File No.: 00091-2
Document No.: 00091-2.02

Subject: Response to Engineering Review Comments
Proposed Residential Subdivision
Part of Lot 13, Concession 2, Geographic Township of Erin
Ospringe, Town of Erin

This letter provides my responses to Section 2.0 of review comments by Ainley & Associates Limited, dated February 2, 2021, related to our Wastewater Servicing Assessment report (FlowSpec Engineering document 00091-2.01, dated September 5, 2019) for the above-referenced development. Each comment is reiterated below, followed by my response:

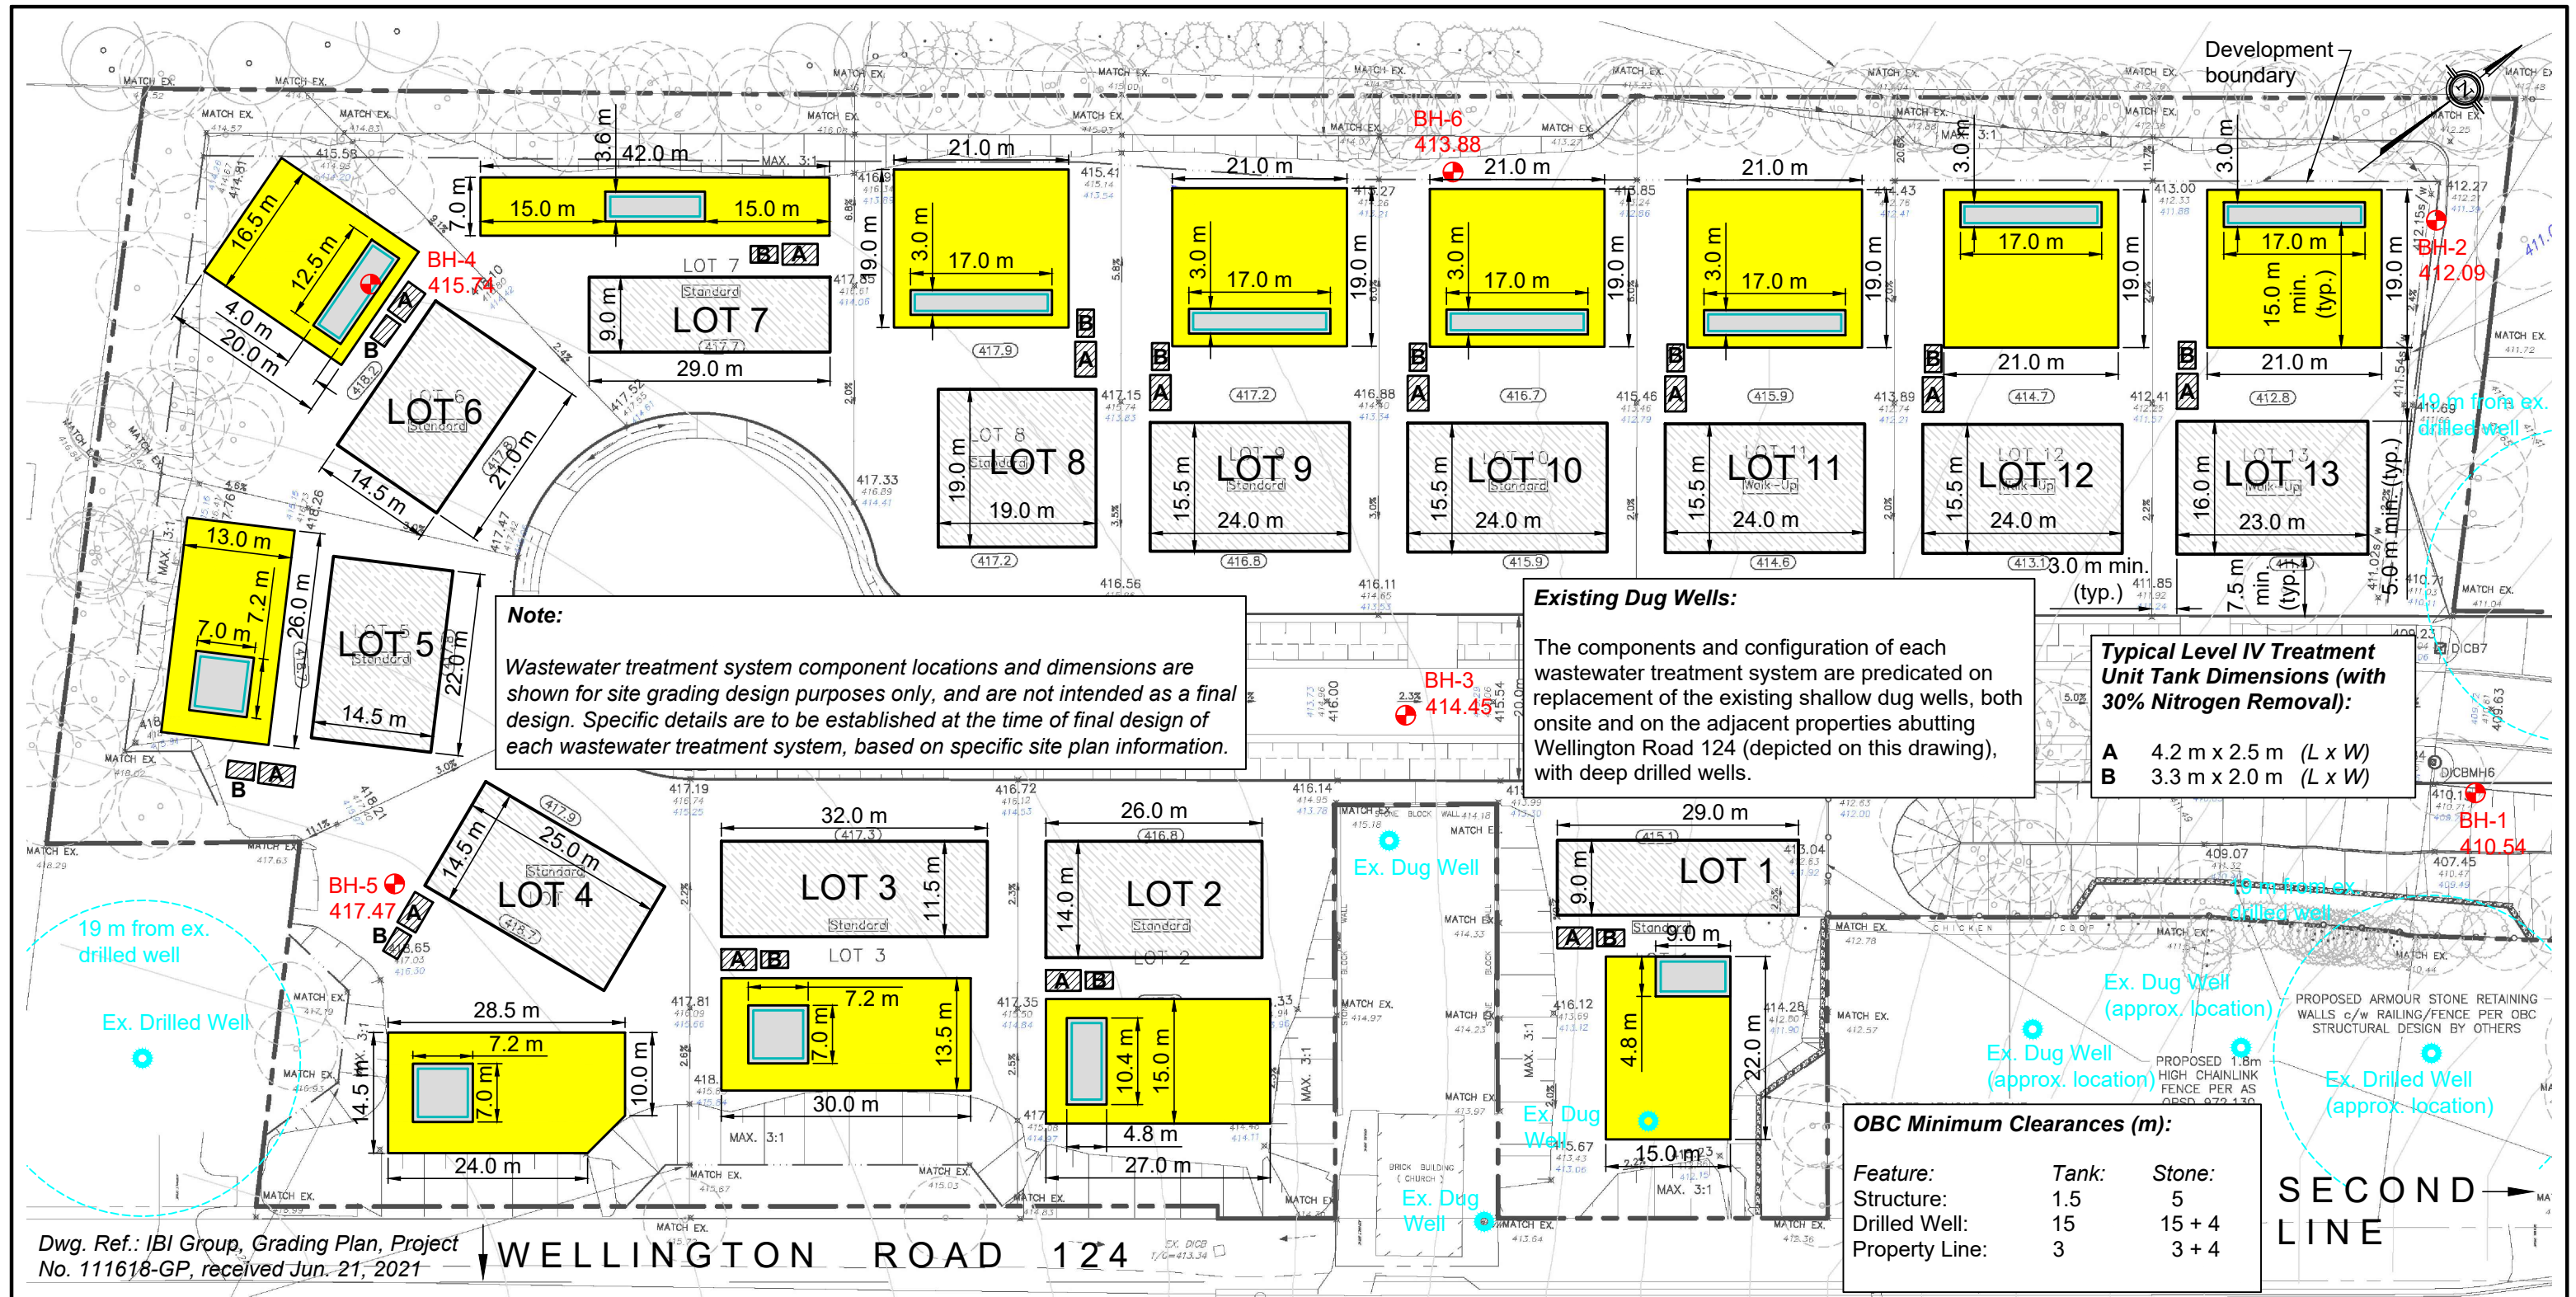
2.4 In Appendix B, Figure 2, Interpreted Water Table Configuration, is borehole data from the CVDE Geotechnical Investigation. The borehole identification numbers should be added to Figure 2.

In addition to my responses above, please find attached our revised Layout Plan which reflects IBI Group's updated Grading Plan, received by us on June 21, 2021.

This figure was created by Chung & Vander Doelen Engineering and appended as a reference. We are not at liberty to change the figure, but the requested borehole numbers were already depicted on our Layout Plan in Appendix A of our report.

The leaching beds depicted on our revised Layout Plan are sized on the basis of the wastewater flows described above.

Set the base of sand elevation beneath the stone layer in each bed to at least 500 mm above the corresponding May 11, 2018 groundwater elevation (third number in the elevation sets above). Increase the distance to 750 mm on Lots 1, and 11 to 13.
